HISTORIC AND DESIGN REVIEW COMMISSION

HDRC CASE NO: 2024-289
ADDRESS: 210 W LYNWOOD
LEGAL DESCRIPTION: NCB 6384 BLK 4 LOT 16 THRU 21
ZONING: R-5, H
CITY COUNCIL DIST.: 1
DISTRICT: Monte Vista Historic District
APPLICANT: Don McDonald /Don B. McDonald Architects
OWNER: Richard Gill
TYPE OF WORK: Stone wall modifications
APPLICATION RECEIVED: August 02, 2024
60-DAY REVIEW: October 1, 2024
CASE MANAGER: Claudia Espinosa

REQUEST:

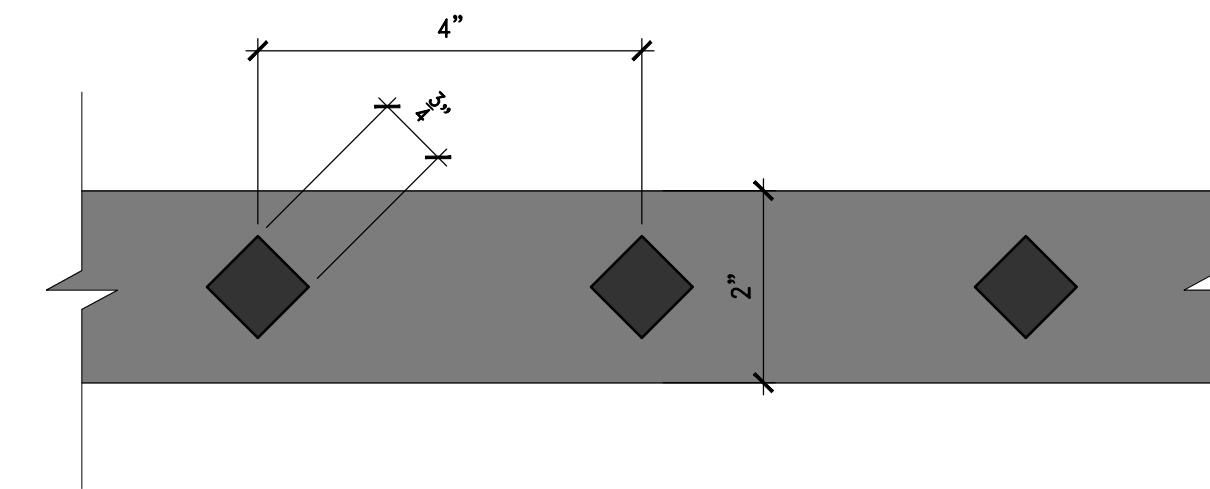
- b. REAR FENCE – The applicant is requesting approval to install a 2.5' wrought iron addition to the existing stone privacy fence for an overall measurement of 6.5' in height. UDC Section 35-514 and the Fences in Historic Districts policy document states that rear yard privacy fences should be no taller than 6 feet in height and feature wood construction. Historic evidence may support installing stone, masonry, or stucco walls. They should be set back from the front façade of the building, rather than aligning them with the front façade of the structure, to reduce their visual prominence. Staff finds the construction of a rear privacy fence taller than 6.5' is generally consistent with UDC.

- i. That the final construction height of the approved fencing may not exceed the maximum height of 6.5 feet as approved by the HDRC at any portion of the fence, and that the wrought iron design of the fencing remains open and transparent. Additionally, the fencing must be permitted and meet the development standards outlined in UDC Section 35-514.

Staff recommends approval of the wrought iron addition to the stone fence based on finding b with the following stipulation:
